Request for Class II Permissive Change

FCC ID: V5PA800

A800 and its below model (s) / item(s): A800 are identical on circuitry design, PCB layout, electrical components used, internal wiring and functions with the model/item No.: A800 which we chose to be tested by SGS, and only different on below:

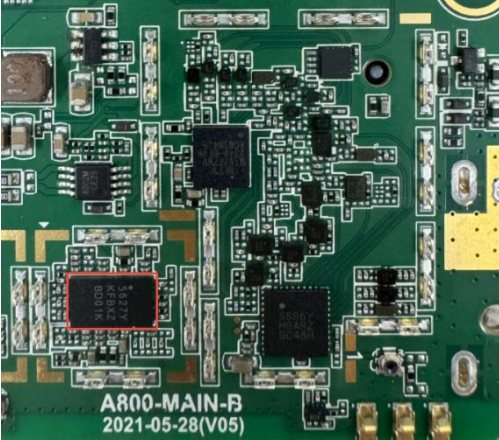
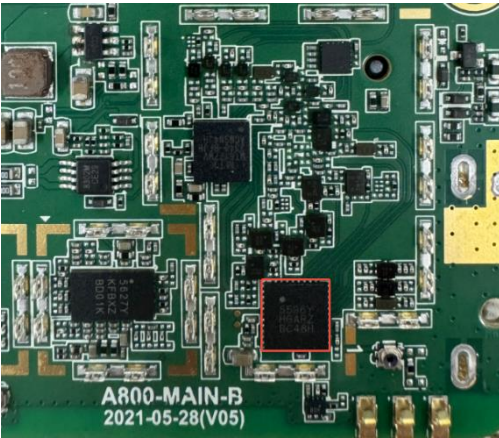
N o.	A800 with V05 Mainboard	A800 with V05 Mainboard(new)	Change note
1			The BOT surface RF PA chip model has been changed, but it's pin to pin compatible and remains the same function.
2			The BOT surface RF PA chip model has been changed, but the packaging remains the same.

3			The CPU on the TOP side has been upgraded, with a new model and the same packaging.
---	---	--	--

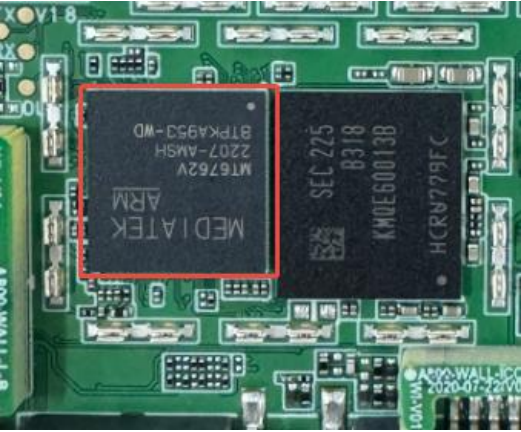
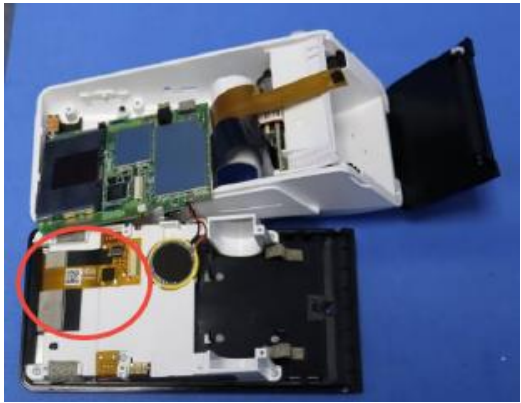
No.	A800 V05 screen	A800 V05 new screen	Change note
1			New incell screen added.

Screen FPC flat cable change.
---	--	--------------------------------------
